SUBJECT: ISSUANCE OF AMENDMENT (TAC NO. M83246)

SAFETY EVALUATION BY THE OFFICE OF NUCLEAR REACTOR REGULATION
RELATED TO AMENDMENT NO. 78 TO FACILITY OPERATING LICENSE NO. NPF-62
ILLINOIS POWER COMPANY, ET AL.
CLINTON POWER STATION, UNIT NO. 1
DOCKET NO. 50-461

Amendment No. 78
License No. NPF-62

Figure 3.1.5-1 Weight Percent Sodium Pentaborate Solution as a Function of Net Tank Volume

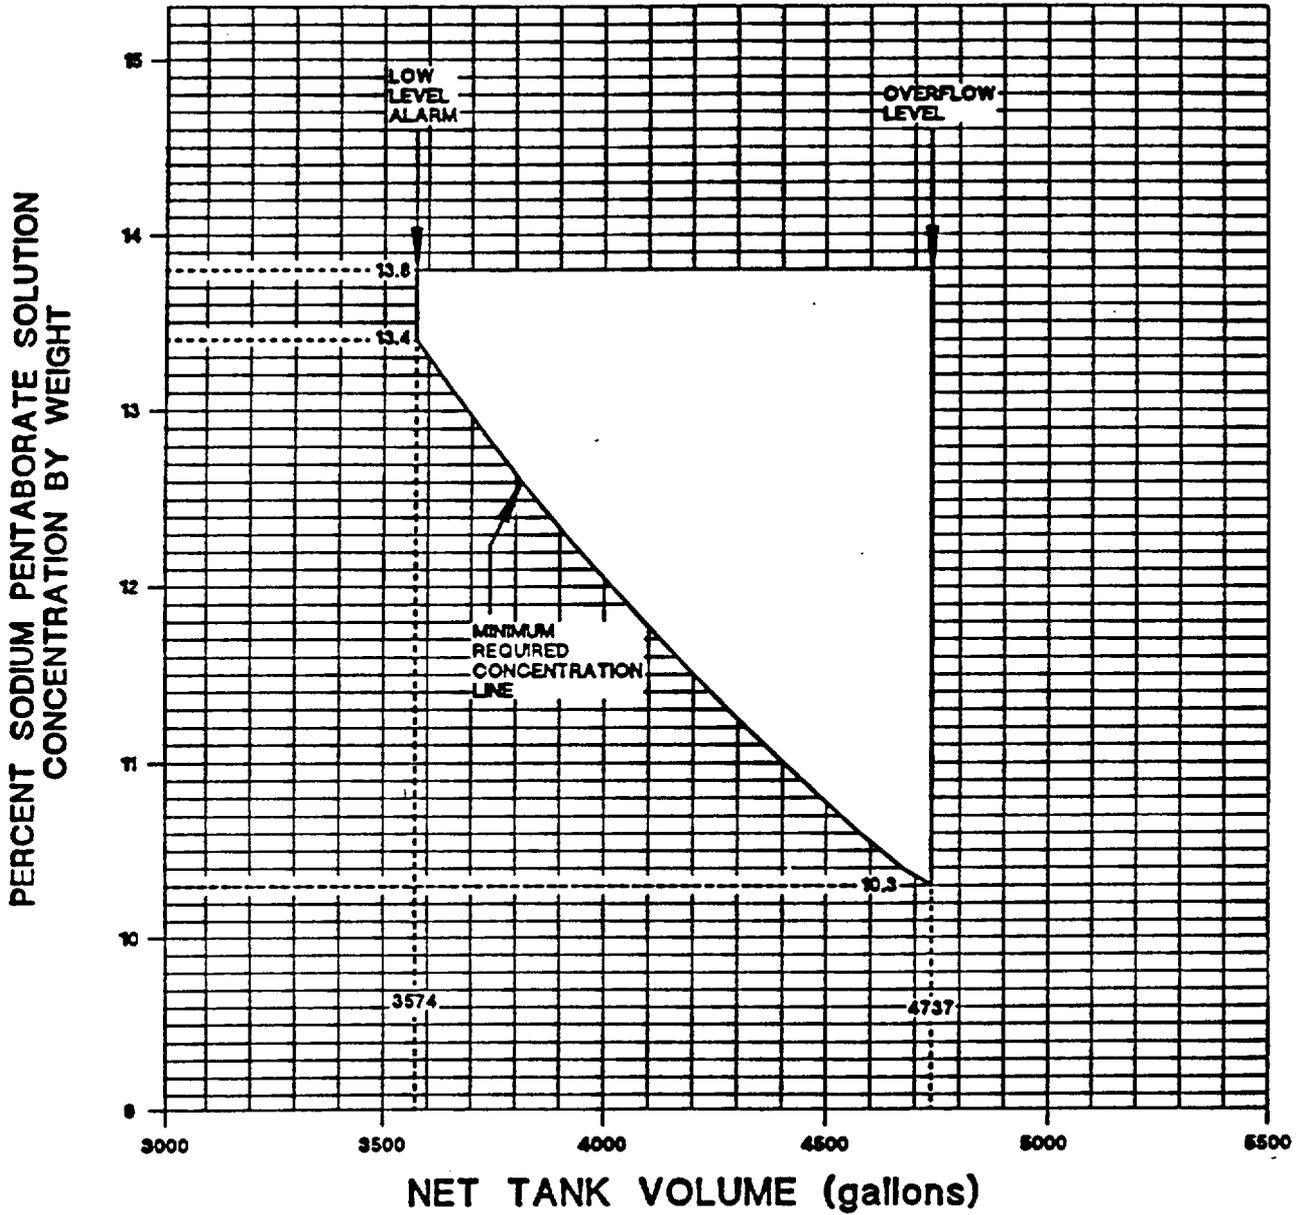
The amendment changes Clinton Power Station Technical Specification Figure 3.1.5-1, "Weight Percent Sodium Pentaborate Solution as a Function of Net Tank Volume," to show the reduction in net tank volume that results from raising the Standby Liquid Control System storage tank level instrument zero to prevent potential air entrainment in the pump suction piping due to vortexing. Additionally the Technical Specification Bases which describe this curve have been revised to reflect the changes.

The analysis that IP did in response to Information Notice 91-12 showed that the SLC system storage tank level instrument zero should be raised 9.38 inches to prevent potential air entrainment in the pump suction piping due to vortexing. As a result of this analysis, IP is proposing the following changes to TS 3/4.1.5:

- (1) Figure 3.1.5-1 is being revised to identify the change in net tank volume associated with the overflow level as well as to remove the

specified high-level alarm setpoint volume and to remove the notes which do not aid the operator in maintaining system operability in compliance with 10 CFR 50.62.

The bases for TS 3/4.1.5 state that a minimum available quantity of 3574 gallons of sodium pentaborate solution is adequate to bring the reactor from full power to a cold, xenon free, shutdown assuming the withdrawn control rods remain fixed in the rated-power pattern. The volume of sodium pentaborate solution below instrument zero is assumed to be unavailable for injection. After raising the instrument zero for the storage tank level instrumentation, it will be necessary to recalibrate the low-level alarm such that the corresponding level continues to be equivalent to a net volume of 3574 gallons of sodium pentaborate solution available in the storage tank. Additionally, the high-level alarm will be recalibrated such that its corresponding level continues to be equivalent to a net volume of 4526 gallons of sodium pentaborate solution available in the storage tank. These changes will result in an increase in the required gross volume of solution in the storage tank, thus, reducing the expansion volume.

The expansion volume within the tank is the volume between the high-level alarm and the overflow level. The high-level alarm is an administrative limit intended to notify the operator that the tank level is approaching the overflow level and to provide sufficient time for any required action. The high-level alarm setpoint does not define a limit required to maintain system operability in compliance with 10 CFR 50.62 nor does reducing the expansion volume impact the operability of the system. The expansion volume provides space for level changes as a result of heating and mixing of the sodium pentaborate solution. Although the proposed change will reduce the expansion volume, it has been determined that the reduced expansion volume will continue to provide adequate space for heating and mixing of the solution.

To reduce potential confusion and aid in operator understanding of the acceptable region for operation of the system, IP's proposal includes the deletion of the high-level alarm setpoint line and its supporting notes from the curve. As discussed above, the line on the figure indicating the net volume associated with the high-level alarm setpoint is provided only for information and does not define a limit required to maintain system operability in compliance with 10 CFR 50.62.

These proposed changes do not affect the net quantity of sodium pentaborate solution that is available for injection. There is no change to the system operation and the design basis for the system remains unchanged. Additionally, the SLC system is still in compliance with the ATWS Rule, and raising the instrument zero by the determined amount has no impact on the system's safety basis or its ability to perform its required function. The staff, therefore, finds these TS changes acceptable.

In support of the proposed TS changes discussed above, IP is proposing revising the Bases for TS 3/4.1.5 to provide additional documentation and clarification of how the boundaries of the acceptable region for operation were developed. The staff has reviewed these proposed TS bases and since they accurately reflect the proposed TS changes discussed above and provide additional clarification, they are acceptable.
